May 17, 2005
LIC-05-0062

SUBJECT: Fort Calhoun Station Unit No. 1, Response to Request for Additional Information on the Revised Relaxation Request for First Revised Order (EA-03-009) Establishing Interim Inspection Requirements for Reactor Pressure Vessel Heads at Pressurized Water Reactors

**Response to Request for Additional Information on the Revised
Relaxation Request for First Revised Order (EA-03-009) Establishing
Interim Inspection Requirements for Reactor Pressure Vessel Heads at
Pressurized Water Reactors**

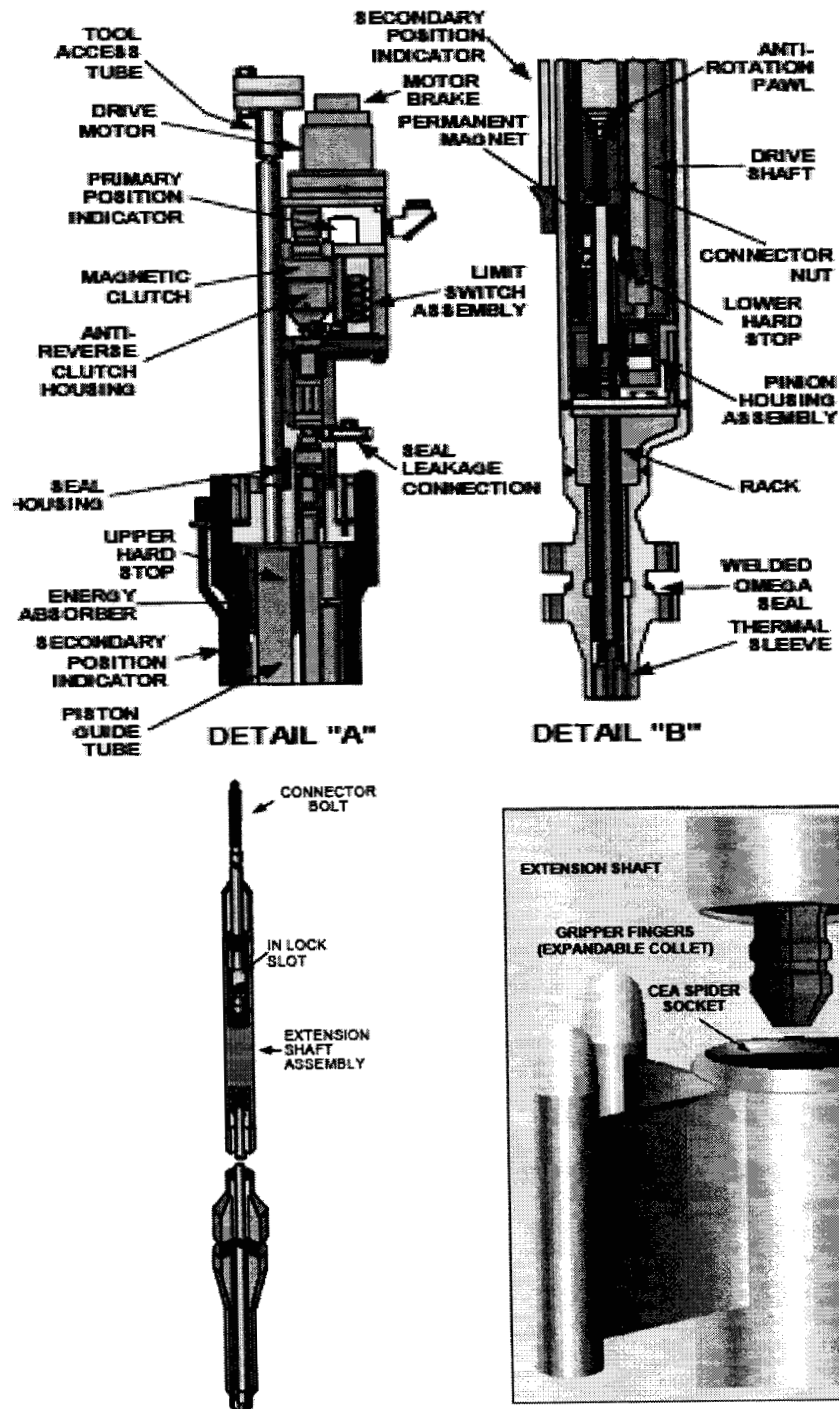
Please provide a detailed explanation of the hardship associated with removal of the thermal sleeve for Control Element Drive Mechanism (CEDM) penetration nozzle 25.

FCS has a “scram weight” at the end of each CEDM extension shaft that precludes CEDM extension shaft removal from the top of the RPV head, necessitating their removal from below the RPV head (See Reference 1, Attachment 1, Figure 3, Page 15). Palisades does not have these weights and can remove their extension shafts from the top of the RPV head.

The basic component arrangement of the system is shown in Detail “A” (upper components) and Detail “B” (lower components). The components of interest in this discussion are as follows:

- Extension shaft assembly – supports the CEA spider
- Connector bolt – supports the extension shaft assembly
- Connector nut – supports the connector bolt
- Rack raises and lowers the rack extension to raise the CEA

The CEDM extension shaft assembly is inserted through the CEDM nozzle from underneath the RPV head and extends through the rack into the piston guide tube.
